Project Office, Town Hall, MANCHESTER M60 2L1
+44 (0) 7970 097 432
www.purcelluk.com

PROJECT STATUS	RIBA Stage 5
CLIENT	Manchester City Council
PROJECT	Our Town Hall
DRAWING TITLE	General Arrangement Plan South Roof 2
SIZE & SCALE	A1: As indicated
DRAWING STATUS	S4 - Construction

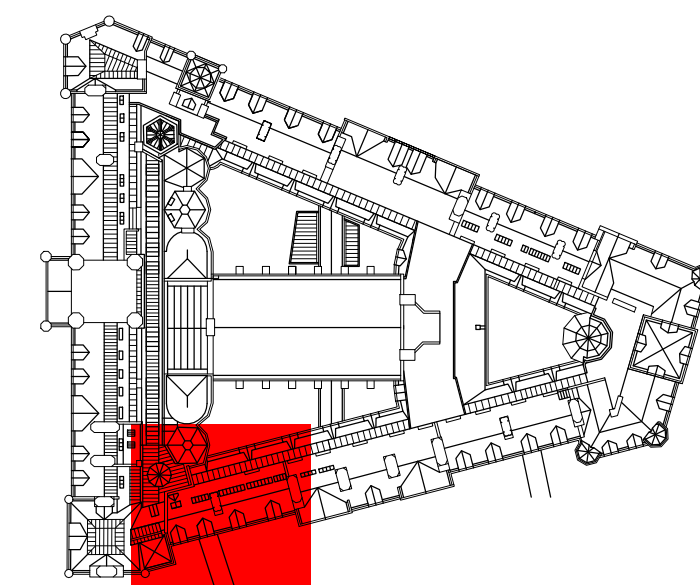
Revision 06
Additional opening and upstand for automatic opening vent added to roof SR09 to correspond with change shown on drawing 4440 - Roofs ECR01, WR16, WCR10 and SR09 AoV and dormer setting out. Revision 01 issued on 13/11/2023

Revision 05
Setting out of dimensions for soil and vent pipe L-SVP 02 added

Revision 04
Upstands for smoke vents SR09_Us01 and SR09_Us02 added to roof SR09
Vent pipe with lead slate added to roof slope SR09
Vent dormers SR09_01 and SR09_02 omitted (substituted with smoke vent upstands)
Vent dormer SR09_03 reference changed to SR09_01
Gantry removed from roof SCR01 and substituted with permanent guard rail fixed to edge of roof

Revision 02
Ladder 06 added see drawing for 7036 details
Dormer Vents added
Gantry added top roof SCR01
Structure for air-conditioning units added
Sections 1/4379, 2/4379, 1/4380, 2/4380, 1/4381, 2/4381, 1/4382, 2/4382, 3/4382, 4/4382, 1/4383 and 2/4383 added
